STAFF REPORT
COMMUNITY DEVELOPMENT DEPARTMENT

HEARING DATE: June 20, 2024
 TO: Planning & Zoning Commission
 FROM: Stacy Hersh, Associate Planner
 208-884-5533
 SUBJECT: Black Rock Coffee - CUP
[H-2024-0011](#)
 LOCATION: 776 N. Cliff Creek Lane (Parcel #R5711030040)

Conditional Use Permit request for a new 1,460-square foot coffee shop including a drive-through, parking, and pedestrian access located within 300 feet of an existing drive-through facility, residential district, and existing residence, on approximately 0.543 acres of land in the C-C zoning district.

B. Lanscape Plan (date: 3/29/24)

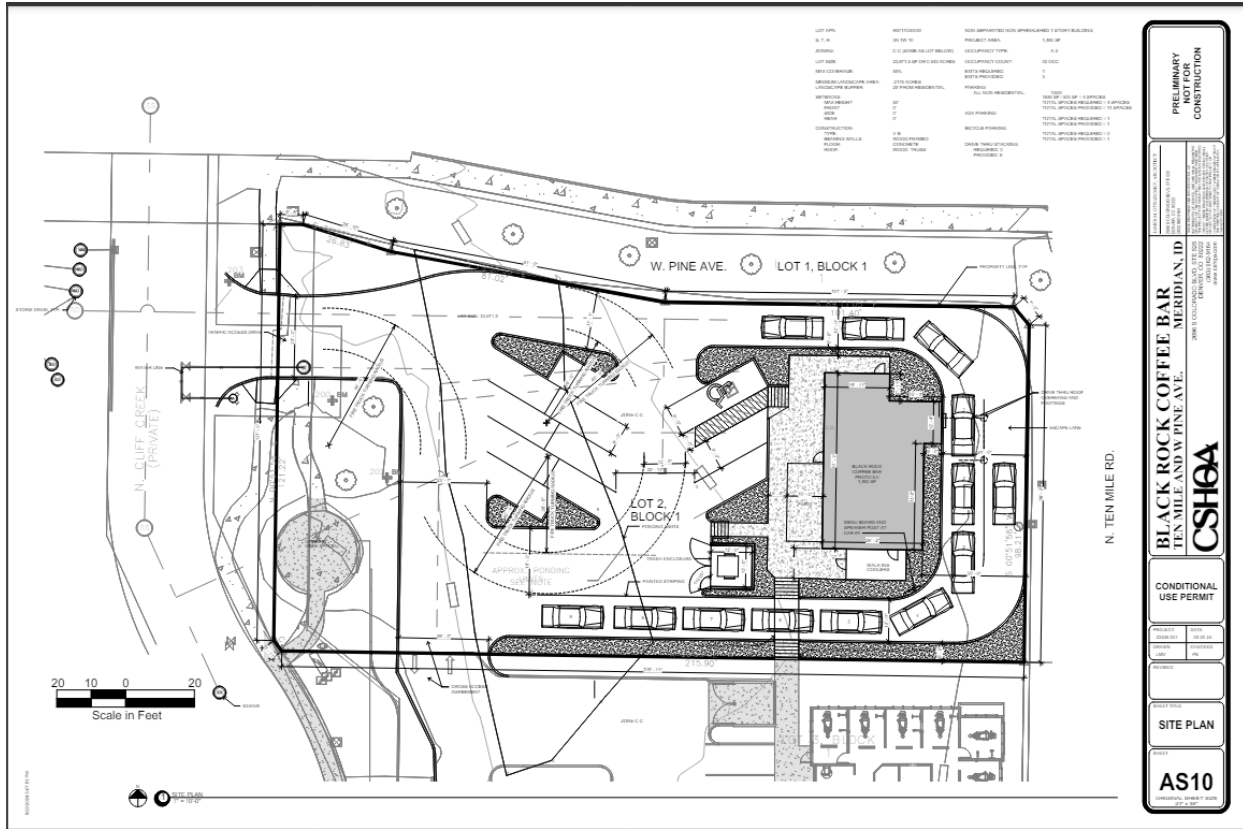
Street buffer: The street buffer along N. Ten Mile Road and W. Pine Avenue was constructed with the improvements for the Mile High Pines development for the common area site improvements. ***Staff recommends that the Applicant protect the existing landscape buffers and trees per [UDC 11-3B-10](#). The landscape planter adjacent to the buffer along the northwest side of the drive aisle entrance/exit should incorporate shrubs and rock mulch (reference figure below). Staff recommends that the Applicant submit a revised landscape plan with the future CZC application.***

Parking lot: Interior parking lot landscaping shall be required on any parking lot with more than twelve (12) spaces. Landscape planters shall contain a minimum of fifty (50) square feet, and the planting area shall not be less than five (5) feet in any dimension, measured inside curbs. The only exception to the five-foot minimum dimension is at the tip of triangular planters located at the end of rows of angled parking. Each interior planter that serves a single row of parking spaces shall be landscaped with at least one (1) tree and shall be covered with low shrubs, lawn, or other vegetative ground cover. Each interior planter that serves a double row of parking spaces shall have at least two (2) trees and shall be covered with low shrubs, lawn, or other vegetative ground cover. Trees shall be centered within the planters and provide urban canopy. Deciduous urban canopy trees shall be pruned to a minimum height of eight (8) feet above the adjacent parking areas. Evergreen trees and class III trees are prohibited in interior planters. *The planter islands appear sparse. The required landscape areas shall be at least seventy (70) percent covered with vegetation at maturity, with mulch used under and around the plants in accordance with UDC 11-3B-5.*

- c. Install additional signage ahead of the southern crossing warning drivers to watch for pedestrians.
 - d. Incorporate shrubs and rock mulch in the landscape planter adjacent to the buffer along the northwest side of the drive aisle entrance/exit in accordance with UDC 11-3B-8C.

- e. The required landscape areas within the planters shall be at least seventy (70) percent covered with vegetation at maturity, with mulch used under and around the plants in accordance with UDC 11-3B-5.

3. The existing landscaping buffers along N. Ten Mile Road and W. Pine Avenue shall remain in place and shall be protected during construction on the site per [UDC 11-3B-10](#).

A. Site Plan (date: 5/20/24)

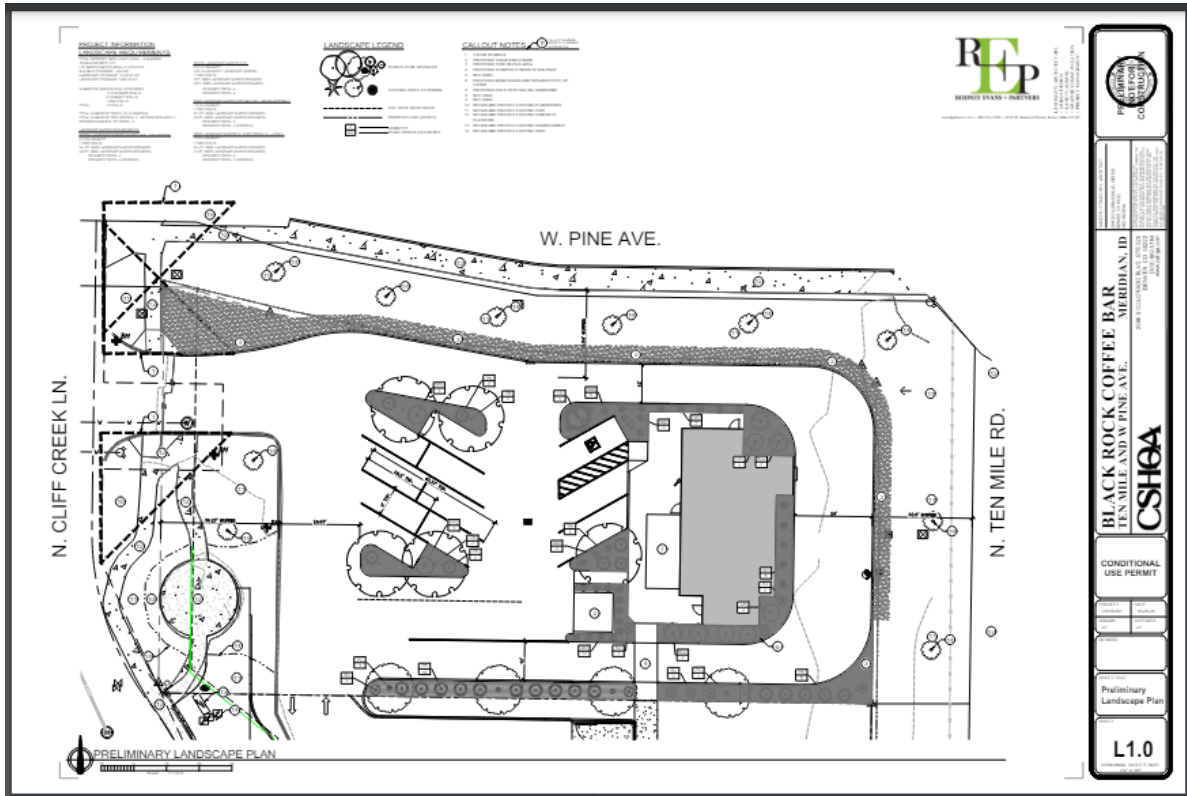
The proposed restaurant features a drive-through lane with space to queue 9 vehicles along with an escape lane located on the west side of the site, outside of the drive-through lane. The drive-through itself starts at the south side of the building and exits at the north side, facing W. Pine Avenue. The concept plan also shows that the stacking lane is separate from the drive aisles and parking, which allows for easy access to the rest of the development.

Staff recommends that the Applicant install additional signage and parking lot striping to clearly mark and guide traffic safely throughout the site.

The stacking lane exceeds 100' in length and an escape lane is required. An escape lane is proposed on the southeast side of the building (see site plan).

The site plan includes one access point from N. Cliff Creek Lane, a private street located on the western side of the property. Vehicles will enter the site from the west, where they will have the option to park in the lot in front of the building or proceed eastwards towards the 12' drive-through lane and the pick-up window, exiting back to the same drive aisle to the north. A second access is provided from a shared access with the property to the south. An escape lane is also provided on the east side of the site, merging into the exit drive aisle to the north. ***Direct access via N. Ten Mile Road is prohibited. The Applicant should provide a copy of the recorded cross-access/ingress-egress easement with adjoining properties to the south [parcel #R5711030060] to the Planning Division with the future CZC and Design Review Application in accordance with the provisions of UDC 11-3A-3A2.***

The proposed plan includes a pedestrian walkway from the main walkway in front of the building connecting to the building residing to the south across the drive-through lanes. Where pedestrian walkways cross vehicular driving surfaces, they're required to be distinguished from the vehicular driving surface through the use of pavers, colored or scored concrete, or bricks as set forth in UDC 11-3A-19B.4. ***The site/landscape plan submitted both reflect compliance with this standard – stamped concrete is proposed.***

- b. Additional signage and parking lot striping are required throughout the site to efficiently and adequately direct patrons to the menu boards and throughout the site with minimal conflict.

- f. Provide a copy of the recorded cross-access/ingress-egress easement to adjoining properties to the south [parcel #R5711030060] to the Planning Division with the future CZC and Design Review application in accordance with the provisions of UDC 11-3A-3A2.
